**APPLICATION FOR  
ZONING RELIEF AND  
CERTIFICATE OF APPROPRIATENESS  
HISTORIC CONSERVATION BOARD PUBLIC HEARING  
STAFF REPORT**

APPLICATION #: COA2019072/ ZH20160078  
APPLICANT: Heather Curless, Greenerstock  
OWNER: Chris Lacey  
ADDRESS: **328 Mulberry Street**  
PARCELS: 094-0006-0304  
ZONING: RM 0.7  
OVERLAYS: Over the Rhine Historic District and Hillside District  
COMMUNITY: Over the Rhine  
REPORT DATE: October 21, 2019  
HEARING DATE: November 4, 2019  
STAFF REVIEW: Beth Johnson, Urban Conservator

The applicant is requesting a reapproval and approval of modifications for a Certificate of Appropriateness and Zoning Relief for the construction of a new single family townhouse that would face Mulberry Street. The original approval decision was signed on June 20, 2017 and both the zoning relief and Certificate of Appropriateness expired on June 20, 2019 as a building permit was not issued within 2 years of the decision date.

**Previously Approved and proposed approved elevations**

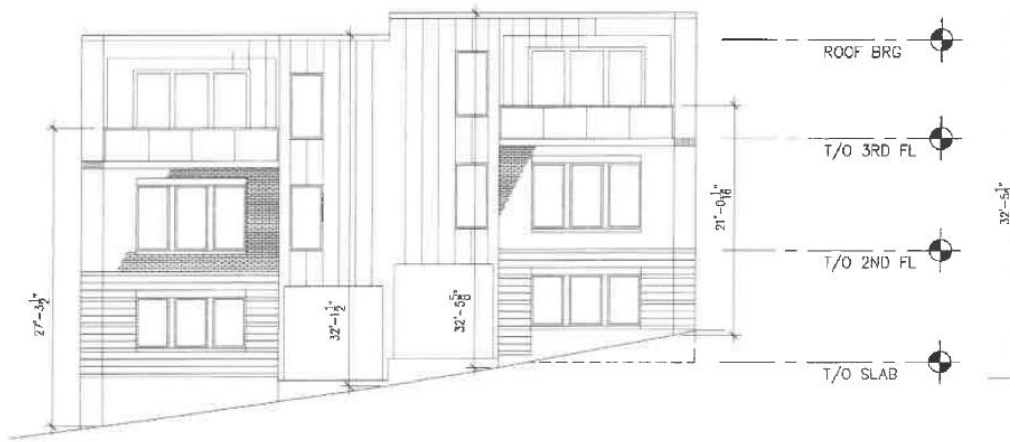
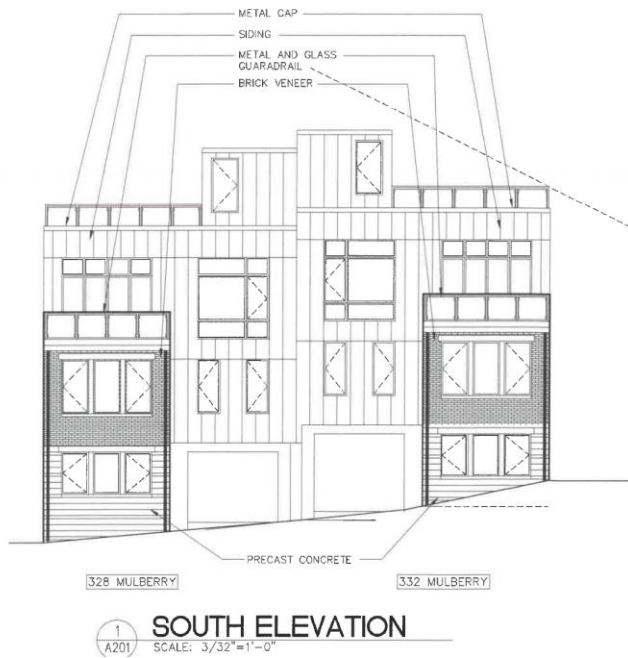
The proposal at 328 Mulberry Street is the same design that was proposed in 2017 with the following changes

- 1) Set back from the front property line 2 feet
  - 2) Addition of a roof access enclosure for a roof deck on the very top.
  - 3) Window placement/configuration
1. Construct new single family townhouse facing Mulberry
    1. The new building will be sided in a dark gray brick, metal panel and precast masonry.
    2. A portion of the buildings will be set a few feet back at the property line and then they will step back for a front facing garage door.
    3. The buildings along Mulberry will have a three floor frontage with a roof deck

- The applicant is now asking for a front yard setback which decreases the rear yard setback that was approved by 2 feet. Staff finds that this is a minor change and it keeps the front yard more in line with the property directly to the west.

- As the applicant has now added a roof access structure the height of the building has increased required a height variance. The height variance is just over 4 feet. The portion of the building that is within this height increase is not an entire floor and the properties that this impacts the most are directly behind the property. There are proposed buildings for these properties, and they are part of the same project/development.

Staff is supportive of the design changes and the addition of the railing and roof access enclosure. The added height helps with the verticality of the property and the railing also provided a more substantial top. As the rest of the design has not changed the design substantially meets the Historic Conservation Guidelines.

**Previously approved east elevation**

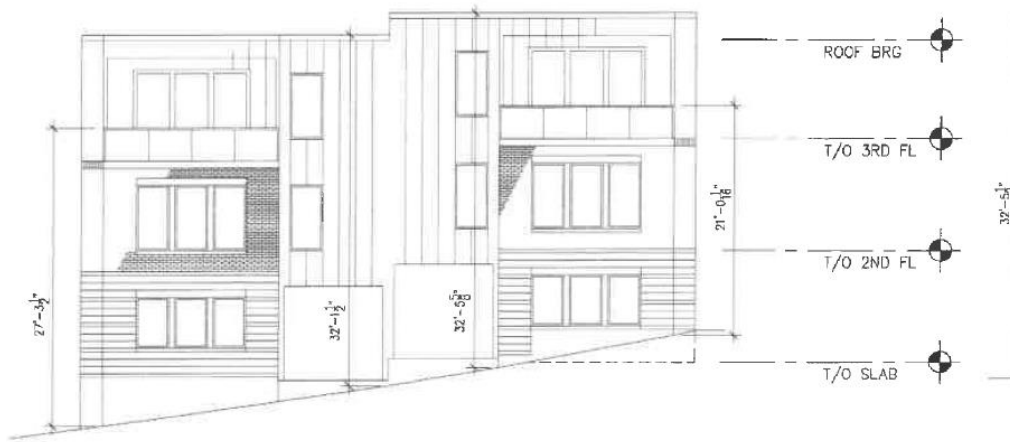
The proposal at 32 Mulberry Street is the same design that was proposed in 2017 with the following changes

- The applicant is now asking for a front yard setback which decreases the rear yard setback that was approved by 2 feet. Staff finds that this is a minor change and it keeps the front yard more in line with the property directly to the west.

- As the applicant has now added a roof access structure the height of the building has increased requiring a height variance. The height variance is just over 7 inches. The portion of the building that is within this height increase is not an entire floor and the properties that this impacts the most are directly behind the property. There are proposed buildings for these properties, and they are part of the same project/development.

Staff is supportive of the design changes and the addition of the railing and roof access enclosure. The added height helps with the verticality of the property and the railing also provided a more substantial top. As the rest of the design has not changed the design substantially meets the Historic Conservation Guidelines.
